# ALERT SERVICE BULLETIN

## WINGS - FLIGHT CONTROLS — FLAPS - MODIFIED OUTBOARD FORWARD FLAP LINKAGE MODIFICATION N953

20 Feb 2008

# ANMD-27-53

Figure 10 Installation of Bellcrank Assembly

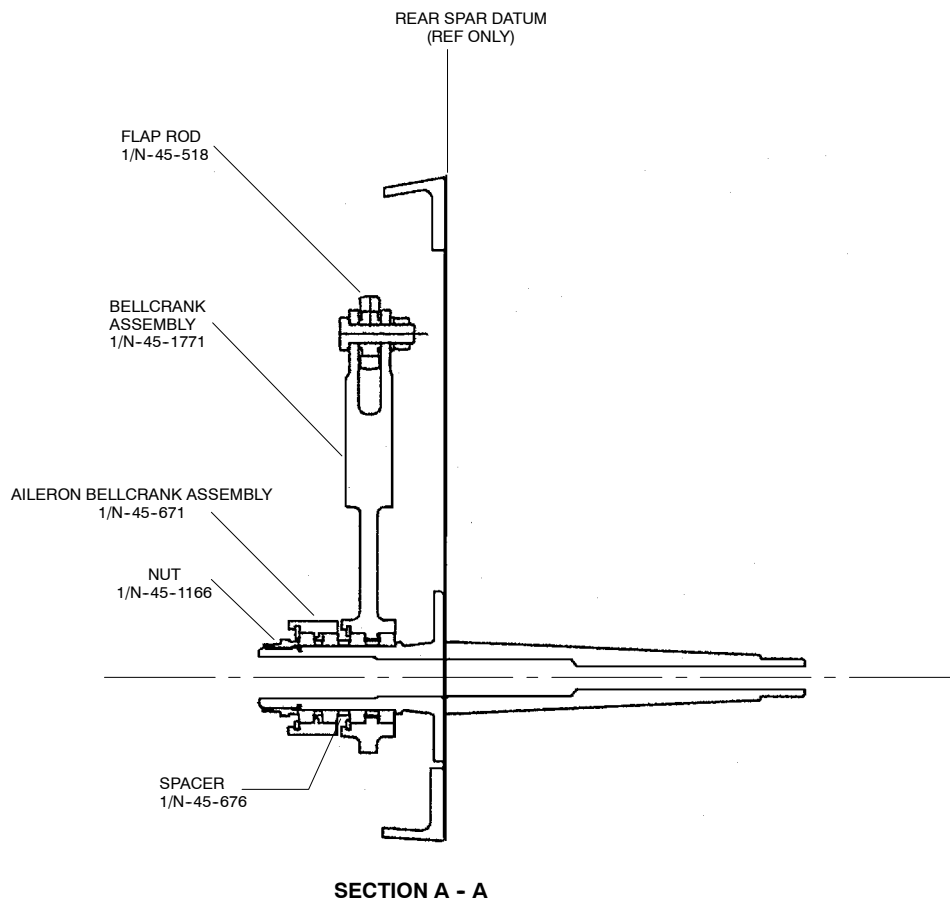
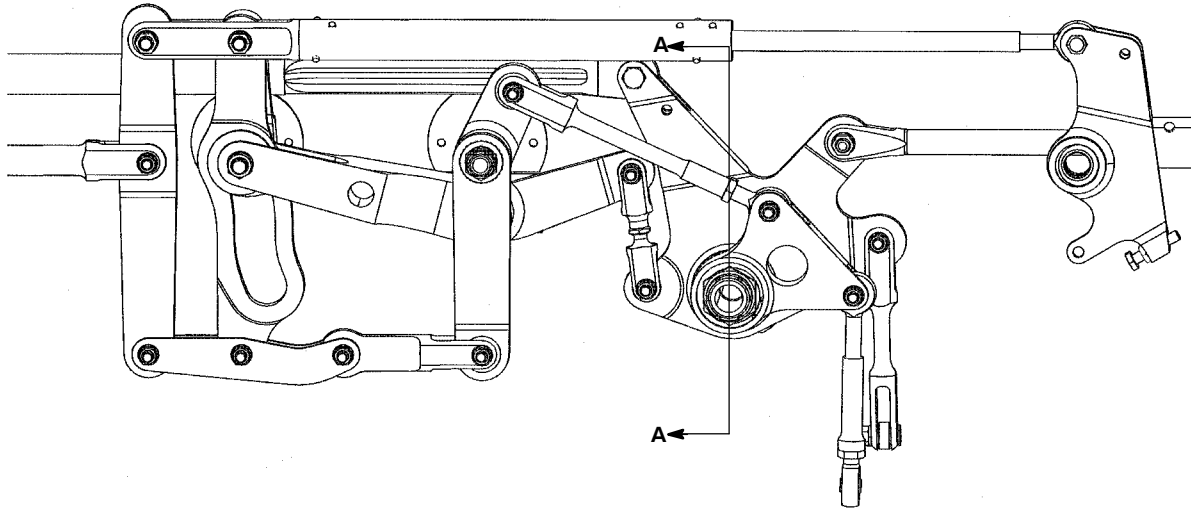
- (5) Fit spacer 1/N-45-676 and existing Aileron Bellcrank 1/N-45-671/2 on spigot (ref Fig 10).
- (6) Attach aileron lever adjustable Link 1/N-45-1061 and Link (1/N-45-328) with the attached Aileron Control Lever 1/N-45-1045/6 to the Aileron Bellcrank.

Figure 12 Bellcrank Assembly in #4 Hinge Bracket

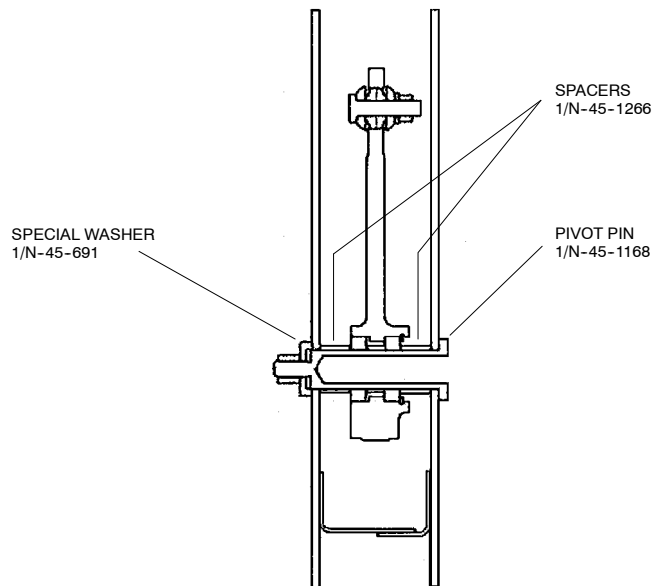
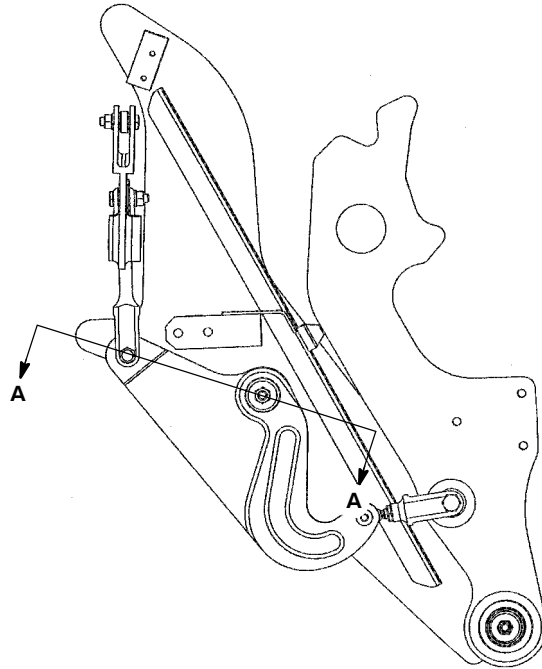
- (1) On bench, using the Bullet (Ref Fig 3, drilled hole inboard) as a shaft offered through the side plate of the Hinge Bracket, assemble the Goosecrank (P/N 1/N-45-1769) and spacers (1/N-45-1266) in correct order onto it (Ref Fig 12). When satisfied prepare the Pivot Pin (1/N-45-1168) for wet assembly (Ref MM Chap 20-30-00). Then place the threaded end into the drilled hole of the Bullet and push it through. Fit the Special Washer (P/N 1/N-45-691) and new self-locking nut (MS21044N4) and torque tighten to 30-40 lb in. Ensure Adjustable Link (P/N 1/N-45-1781) protrudes through slot in rear web and that the Goosecrank rotates through the enlarged slot.

Figure 13 Modified Mass Balance

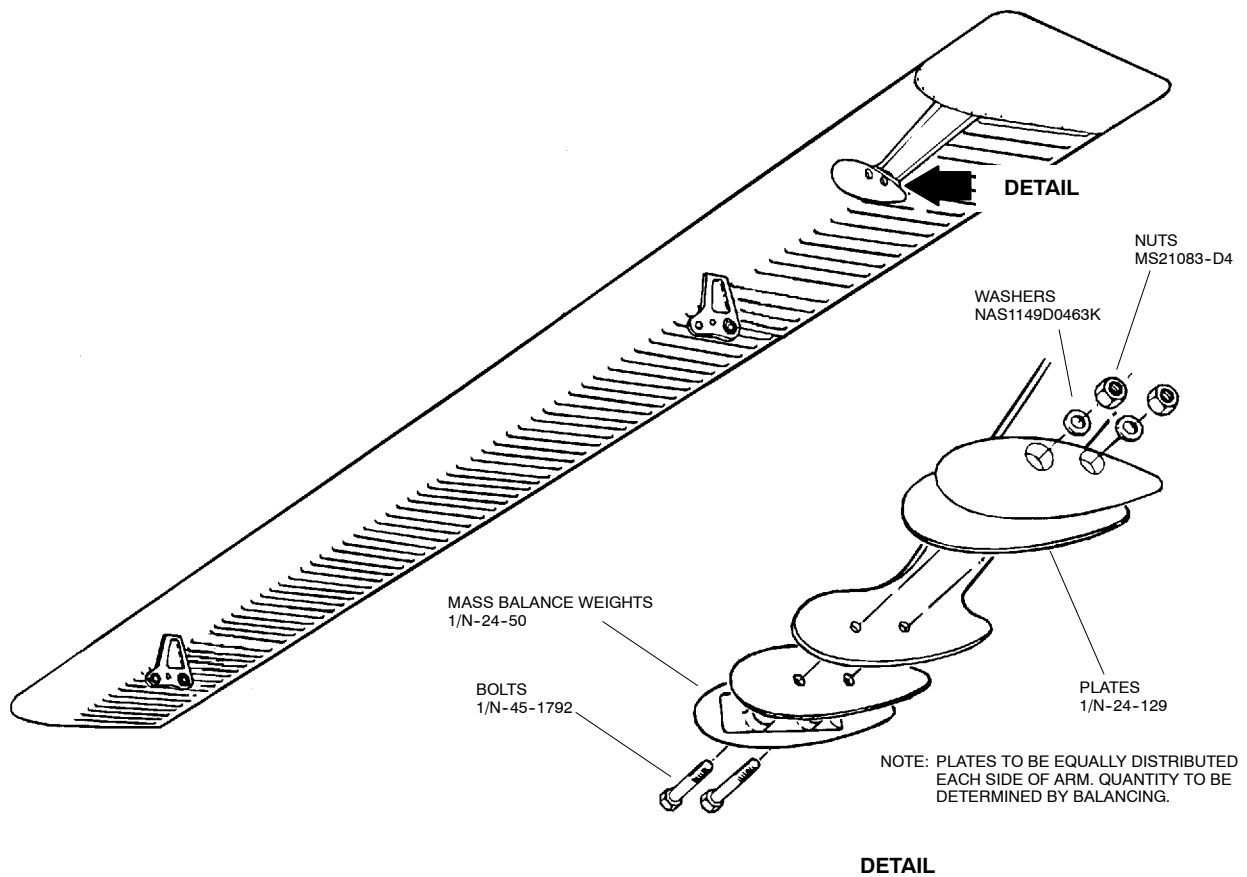
- (4) Suspend a bob weight of  $29.98 \pm 0.09$  oz ( $0.850 \pm 0.0025$  kg) from the trailing edge of the aileron by a string taped to the uppermost surface and draped over the trailing edge.
- (5) Re-assemble Mass Balance with approximately 16 additional Plates (1/N-24-129) added equally each side of Mass Balance Arm, and Bolts (1/N-45-1792) and new Nuts (MS21083-D4) and Washers (NAS1149D0563K).

Mod N953 requires the Mass Balance, Bobweight and total Aileron weight to be increased.

Figure 15 Aileron Balance Graph - Boundary Envelope

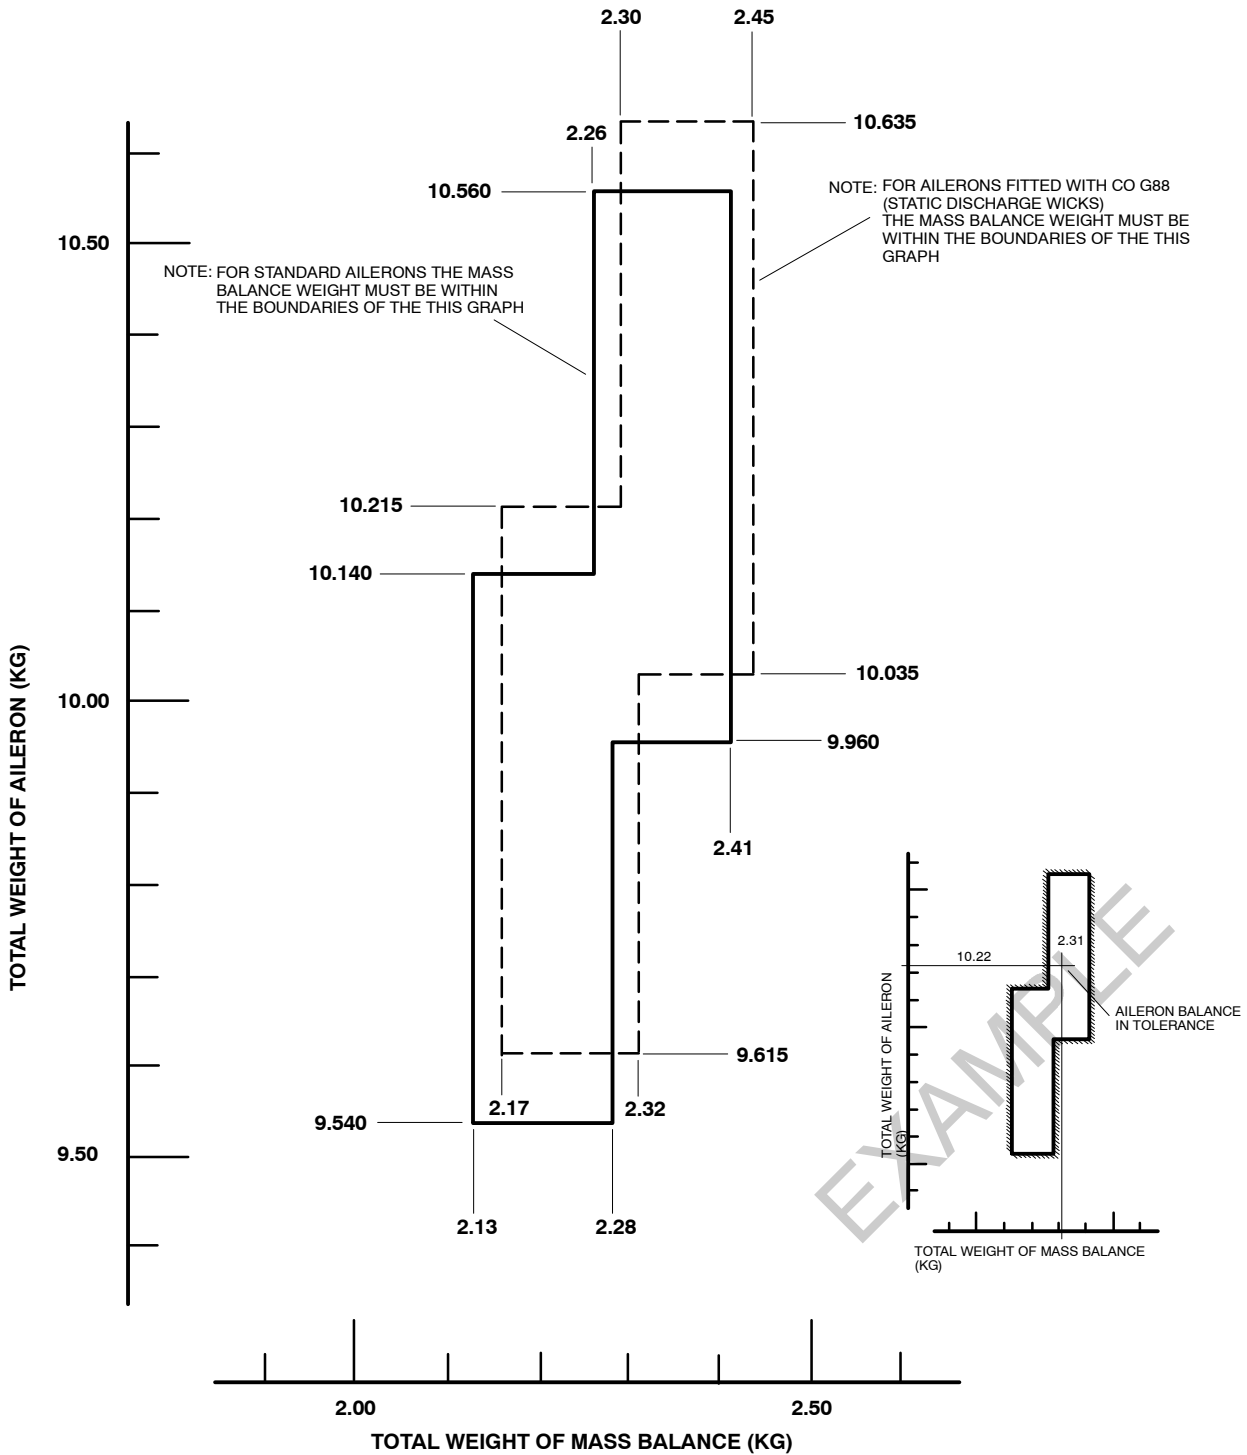
- (10) Remove the bob weight from the aileron trailing edge then remove the aileron from the balancing fixture, and weigh the aileron as removed from the fixture. Check that the point of intersection of the total weight of the aileron with the total Mass Balance weight is within the boundary of the envelope in Figure 15.
- (11) Record all weights.
